**RE: Fruitridge Shopping Center (P18-007)**

WALKSacramento reviewed the project routing for Stockton and Fruitridge Shopping Center (P18-007) and emailed comments to the City on July 20, 2018. Revisions made to the site design addressed several of the issues we identified – pedestrian plaza at the corner, pedestrian travel path at the coffee kiosk, bike parking locations and trees. However, our primary concern with the site design remains – the Starbucks doesn't address the street and the drive-through lane separates the building from the public sidewalk.

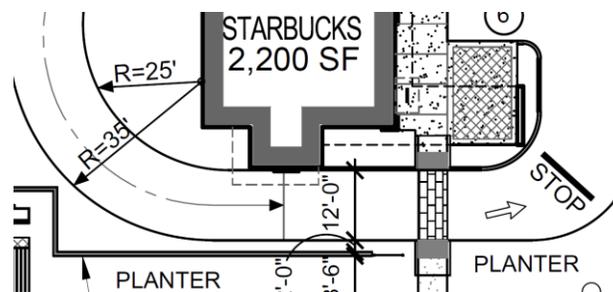
The Starbucks should welcome pedestrians from the corner with an active front or corner facing the intersection. The City's General Plan policy *LU 4.1.3 Walkable Neighborhoods* states "The City shall require the design and development of neighborhoods that are pedestrian friendly and include features such as ... buildings that define and are oriented to adjacent streets and public spaces, limited driveway curb cuts, ..." Also, the General Plan listing of key urban form characteristic for suburban corridors includes "Building façades and entrances directly addressing the street and have a high degree of transparency on street-facing façades."

How does the Starbucks define and orient itself to the street? The Starbucks building is at the corner of two streets well-traveled by pedestrians but it has very little relationship to the street and pedestrian environment. The drive-through lane and a 3-foot-tall solid wall is between the building and the corner; the wall facing the corner has no activation or transparency other than two small windows; and the service door will contribute little to street activation.

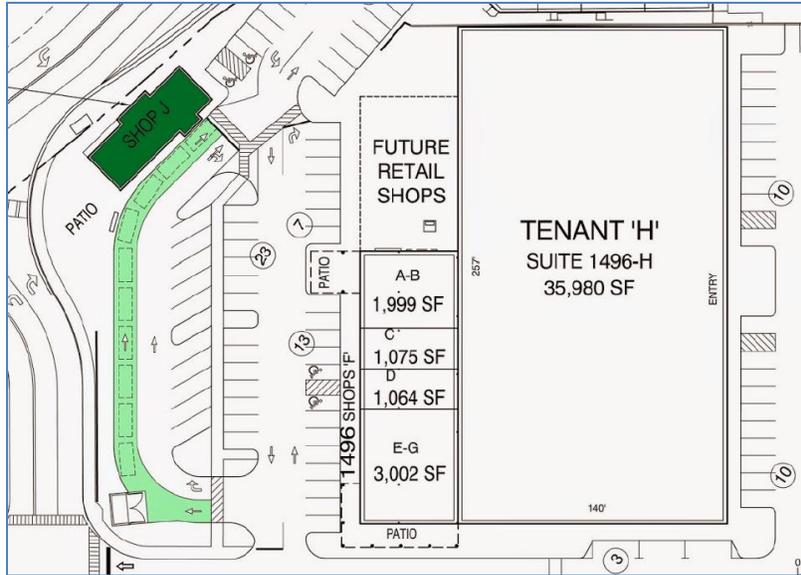
The Fruitridge Shopping Center project removes a driveway that is hazardously close to the corner, but the Starbucks drive-through lane effectively adds two curb cuts. Although the curb cuts are not at the street, conflict points with pedestrians remain at the drive-through lane pedestrian crossings. The drive-through exit will present the greater risk to pedestrians because drivers can be distracted as they leave the pickup window which is less than a car length from the crosswalk.

The drive-through entry is also a concern for the potential of autos blocking the pedestrian crossing. The traffic analysis appendix in the draft Mitigated Negative Declaration states ITE research indicates the drive-through 11-car queue length should be adequate for the vast majority of drive-through volumes. The analysis for the CVS, though, uses a report by a consultant to

support the pharmacy drive-through length. It should be noted that the same consultant recommended a stacking length of 13 cars for coffee shops with drive-throughs. Anecdotally, we have seen the stacking extend over the drive-through entrance crosswalk at another Starbucks in Sacramento. We could have the same situation at the Fruitridge Shopping Center Starbucks.

**The optimum resolution of the issues we've mentioned above would be to face the Starbucks building towards the corner or one of the two streets, and locate the drive-through lane on the shopping center side of the Starbucks.** A similar situation of siting a Starbucks at the street corner of a shopping center in Decatur, Georgia is shown below with the Starbucks entrance at the street sidewalk in a commercial area adjacent to residential neighborhoods that are not very walkable.

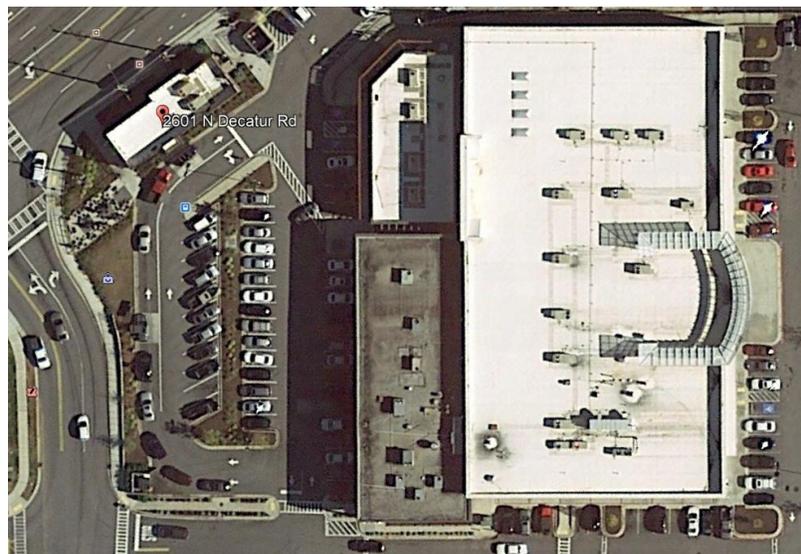
The design that was constructed also incorporated an ADA ramp between the corner and the parking lot, as shown below.
